# CITY OF SAN ANTONIO

Re: Santa Fe

MDP # 742

The City Staff Development Review Committee has reviewed Santa Fe Master Development Plan M.D.P. # 742. Please find enclosed a signed copy for your files. Your plan was accepted, however please note the following:

**SANTA FE SUBDIVISION  
MASTER DEVELOPMENT PLAN**

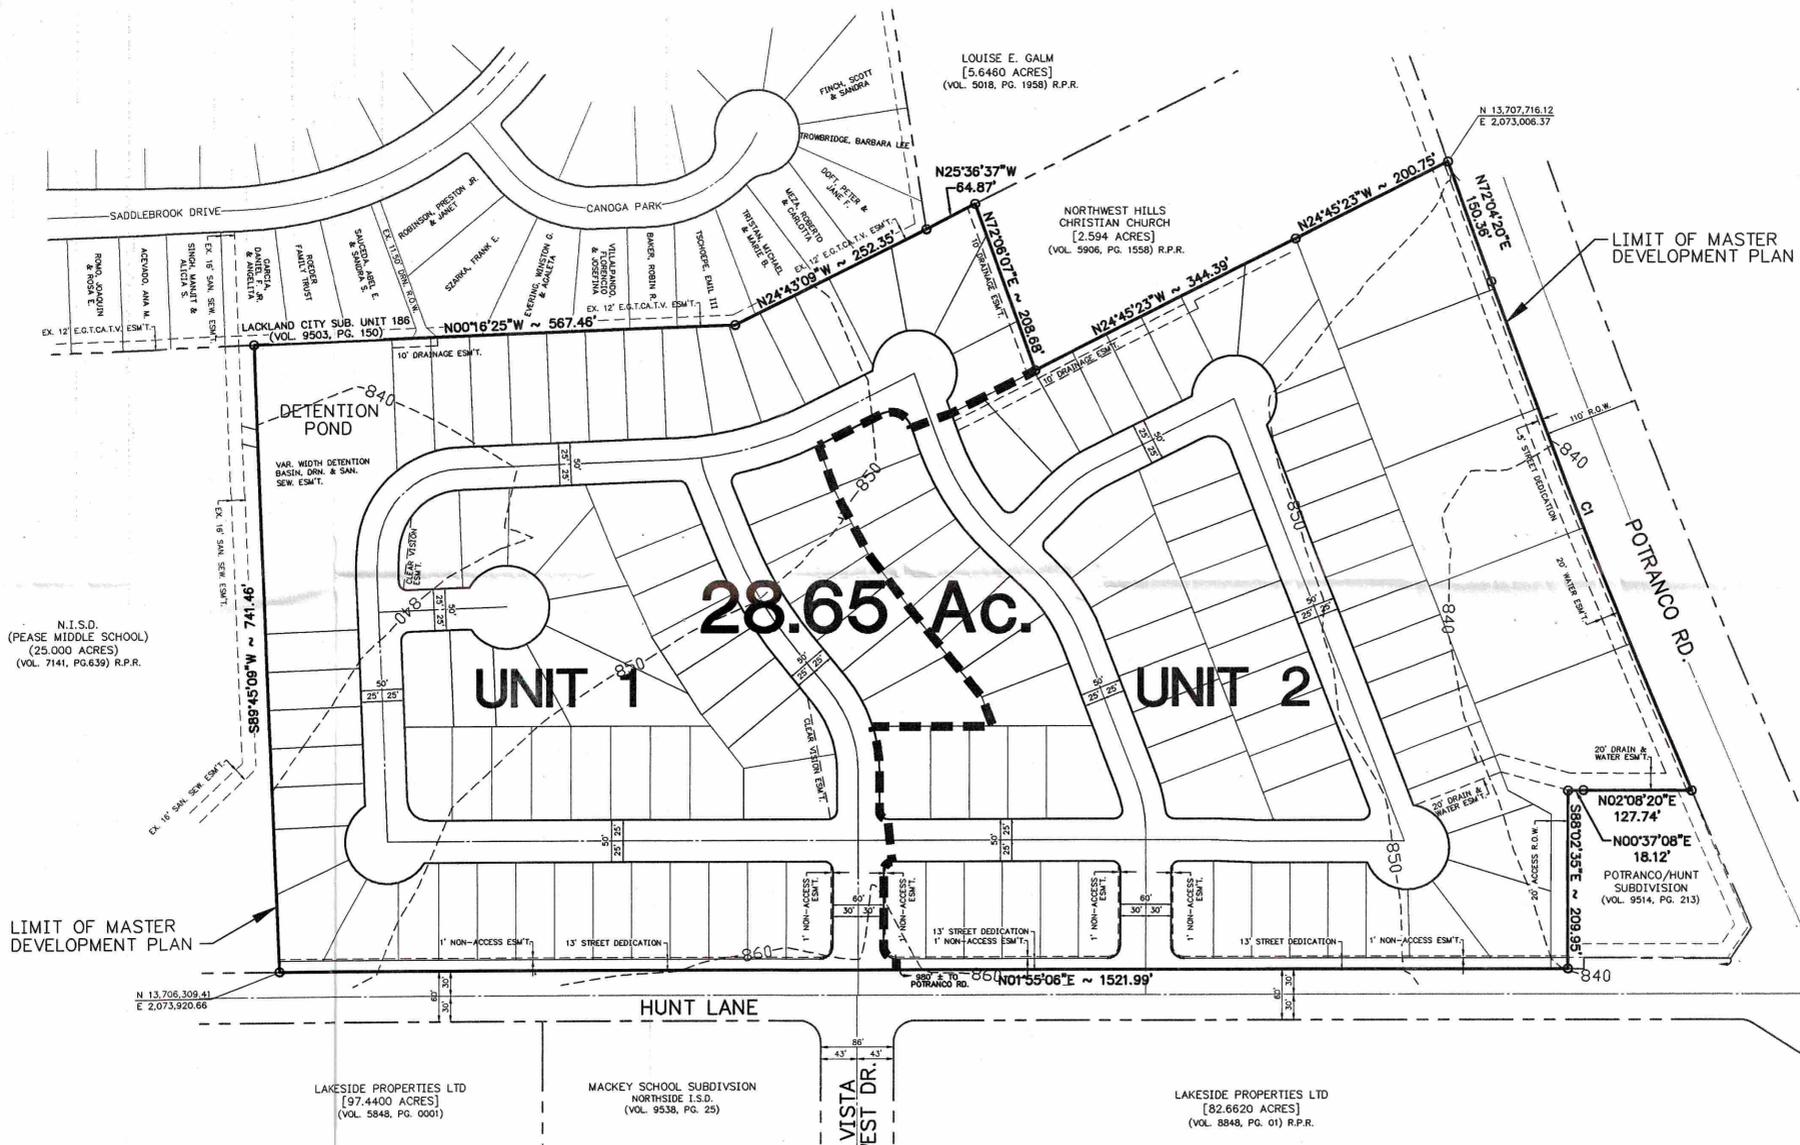
- In consideration of public safety and convenience, excessive grades by reason of topography should be avoided in street layouts and arrangements.
- Any access and R.O.W. issues along state facilities will need to be resolved with the Texas Department of Transportation (TXDOT). For information about these requirements you can contact TXDOT at 615-5814.

- This development will need to comply with tree preservation ordinance #85262. For information about these requirements you can contact Building Inspections at 207-7102.

- It will be expected that you will plat all of the property depicted in your Master Development Plan (M.D.P.) to include floodplains, drainage areas and open space.

- I would encourage you to work closely with the school district, so that they can plan accordingly.
- Development Services, TIA Engineering Section has indicated as part of their conditional approval, the following conditions shall be met by the developer at the time of final plat submittal

- a.) A level two TIA was originally submitted as the Hunt Lane / Potranco 26, POADP and approved for 29 acres of commercial use. This property is now proposed to consist of 146 single family detached homes with five small commercial lots facing Potranco Rd.

Two residential streets are proposed to access Hunt Lane. As indicated in the approval for the original Hunt Lane / Potranco 26 Road, the commercial lots will be limited to two access points onto Potranco Road with an understanding that the development would include shared access and internal circulation.
